REQUEST FOR DESIGN EXCEPTION TO PUBLIC ROAD STANDARDS: MUP 12-019; 1250 Tavern Road, Alpine, CA 91901; KIVA 11-0159052.

Department of Public Works (DPW) staff has reviewed your application for Exception to Public Road Standards dated July 20, 2012, submitted to the County on September 28, 2012. The request is to reduce the 300-foot driveway separation requirements of Section 6.1.C.2, for the proposed project's driveway on Tavern Road from the existing driveways and I-8 off-ramp.

Request for a
Design Exception to a Road Standard
and/or Modification to Project Conditions

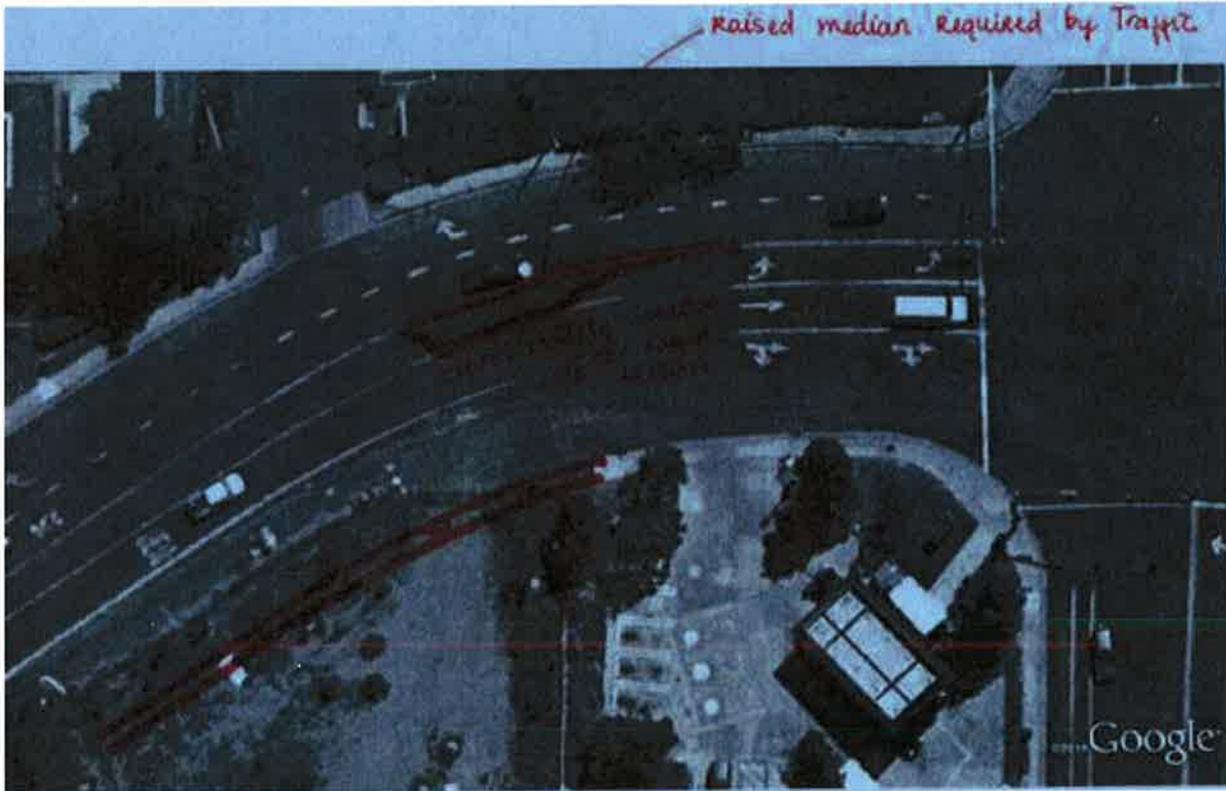
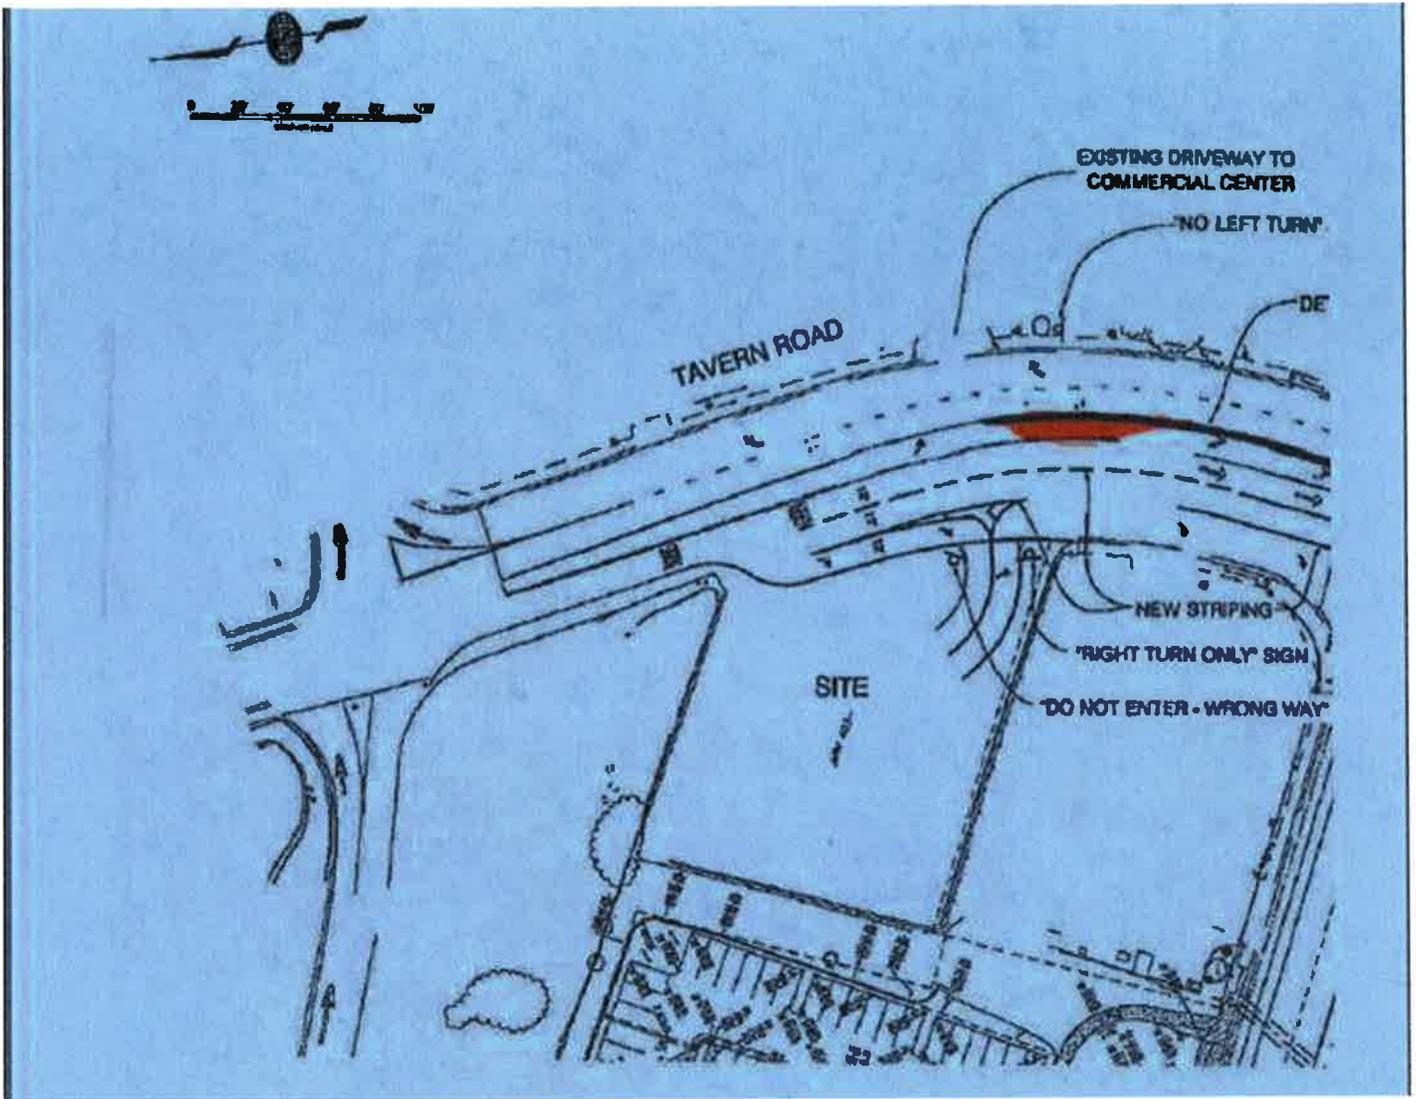
I'm not requiring a raised median just a painted one. The text on the exhibit I prepared wasn't written by me.

Mike,
Yes, the top drawing is yours.
I drew the raised median on the second one so we can have a completed picture.

You are not opposed to a raised median, but do we need a raised median in order to approve or support the proposed driveway location/driveway separation as requested in the exception request?

The drawing on the top looks to be my drawing. I've not seen the drawing below but it looks like the representation of a raised median.

The challenge with this driveway access configuration is keeping the existing driveway on the opposite side of the road full access while limiting the carwash driveway to right in right out. This also has to be done within the lane widths that we already have.

I'm not opposed to a raised median but it looks like it will be blocking the left turn out of the shopping center driveway. Is the shopping center OK with this?

Would you please clarify the purpose of stopping the raised median by the existing commercial driveway (across the proposed project, MUP 12-019).

Yes the CPG reviewed the project with the raised median and right in, right out and are on board with the project.

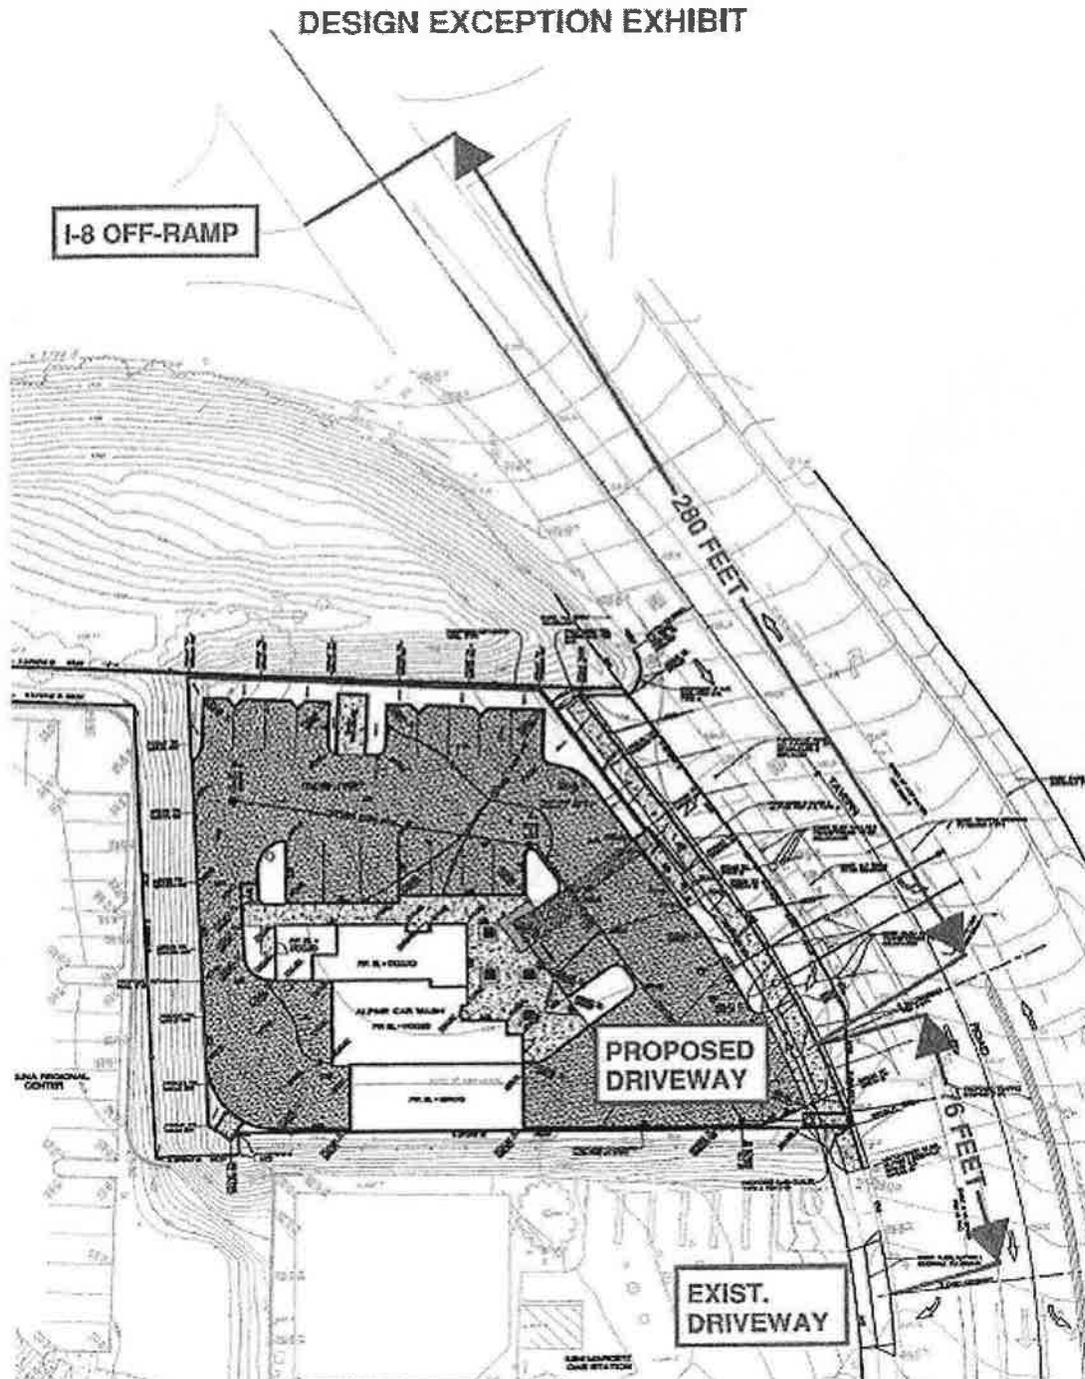
Just to clarify, there are no design exceptions or encroachment into Caltrans right-of-way. Therefore, as stated previously, we have no comment on this project. This proposed driveway is approximately 200 feet from the existing EB I-8 exit ramp curb return, which meets the preferred 100 feet access control, per Caltrans HDM, Chapter 500, section 504.8, and previously email to Nick Ortiz.

Tavern Road is currently a 35 mph street with a two-way left-turn median, which turns into a double yellow island before our right-of-way line begins. It is the discretion of the County to implement a raised median to control left turns on Tavern Road, adjacent to Alpine Auto Wash & Lube. The double yellow striped island within Caltrans right-of-way can be built into a raised median per Caltrans HDM, Chapter 400, section 405.4 (2). *"In urban areas, posted speeds less than or equal to 40 miles per hour allow more frequent use of curbed islands. Local agency requirements and matching existing conditions are factors to consider."* Again, it is the discretion of the County how to enforce the right-in/out access.

However, it has been researched and documented based on the speed and volumes of the facility, that roadways with a nontraversable median are safer than those with Two-Way Left-Turn Lanes (TWLTL), particularly on high volume roads.

We have documented for your records a "no-comment" letter, and confirmed with this email there are no design spacing issues inconsistent with our standards. This email also offers the suggestion to the County that based on speed and volumes, when a nontraversable raised median could be considered, that if chosen by the County could be built into our double yellow striped island, which would need to then be approved under a Caltrans Encroachment Permit.

raised median required by Traffic

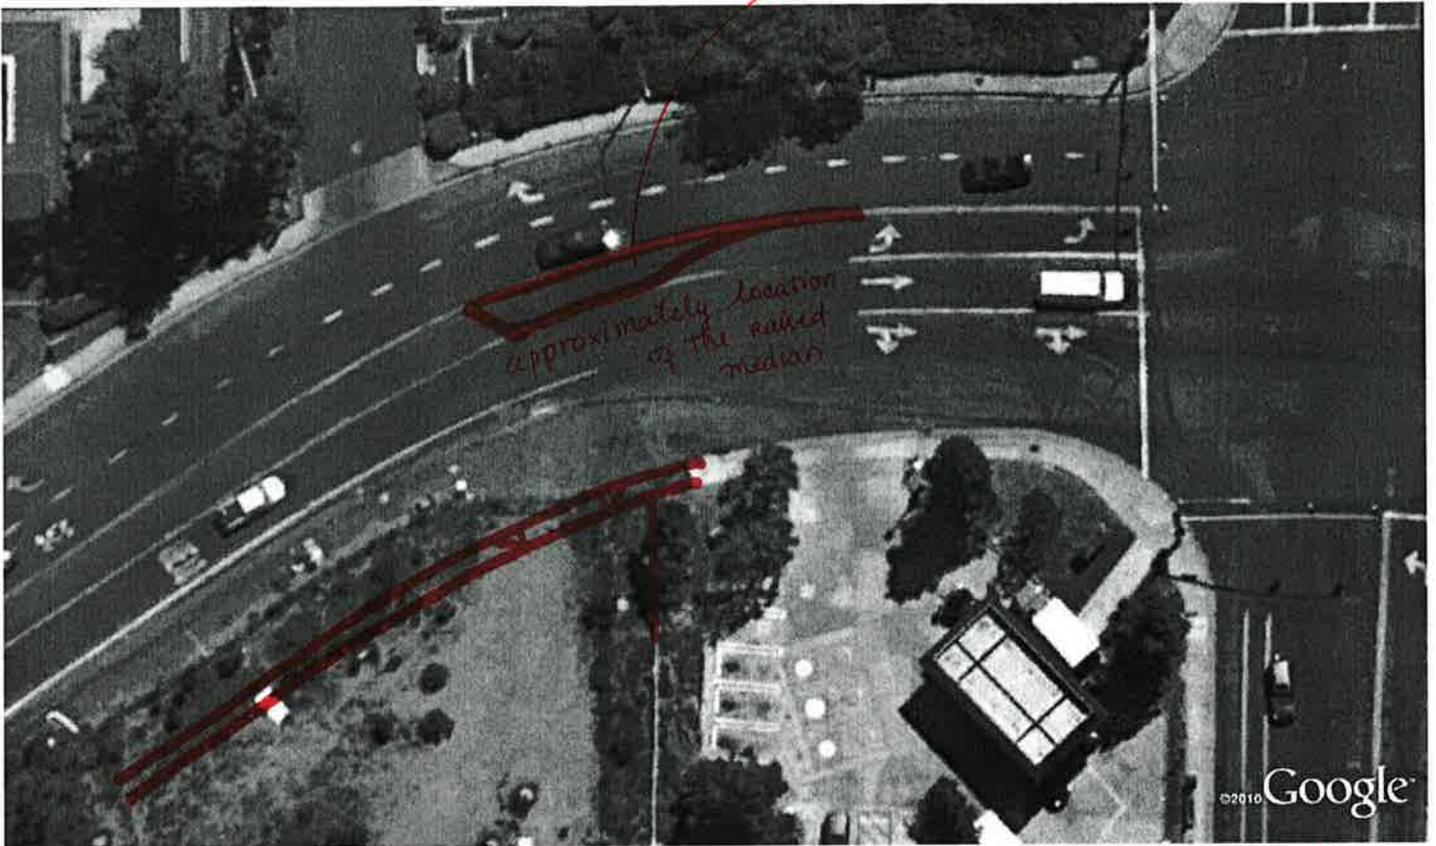
CALTRANS 400' span

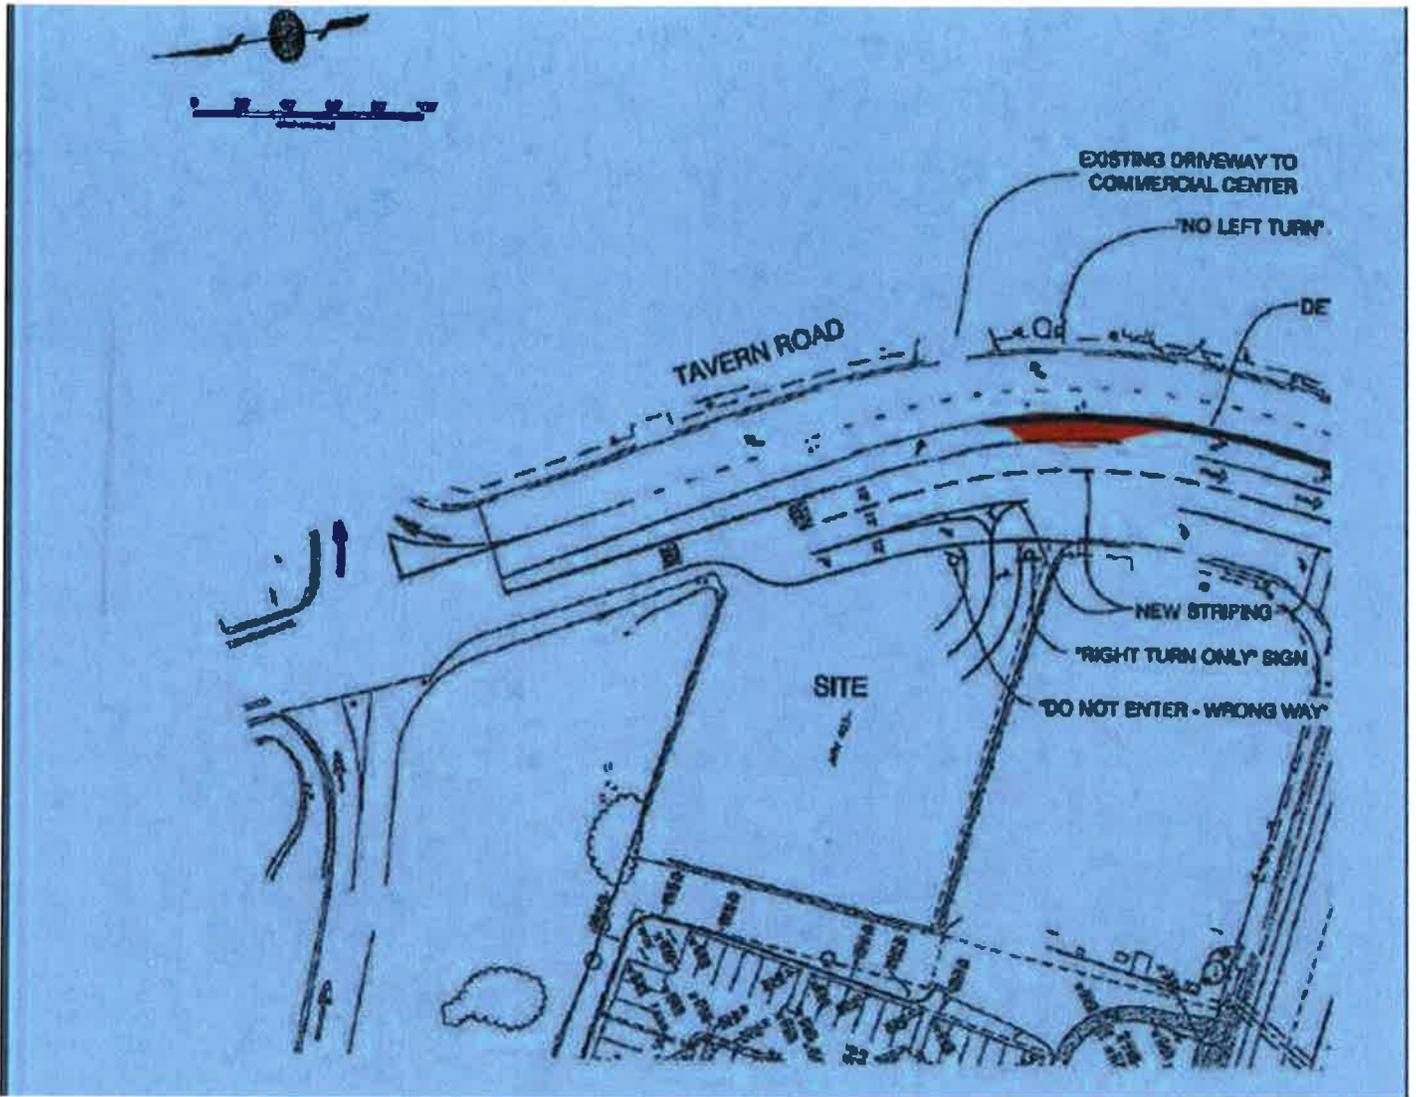
My project, MUP 12-019 is located between K-Circle Gas Station and I-8 off-ramp, we will condition the project to widen Tavern Road along the project frontage to provide 2 through lanes and a right in right out, see below. Would the discretionary project widening impact the CIP drainage project?

Per our discussion the future phase 2 drainage project will be limited to Alpine Boulevard from South Grade to Tavern and will have no impacts to the proposed MUP 12-019. There is a cleanout storm drain structure being constructed in the next two weeks in Tavern Road just north of its intersection with Alpine Blvd. This will be complete and in place at the time of the future MUP 12-019 and the future phase 2 streetscape and drainage project in Alpine Boulevard.

The discretionary project widening will not impact the future CIP drainage project.
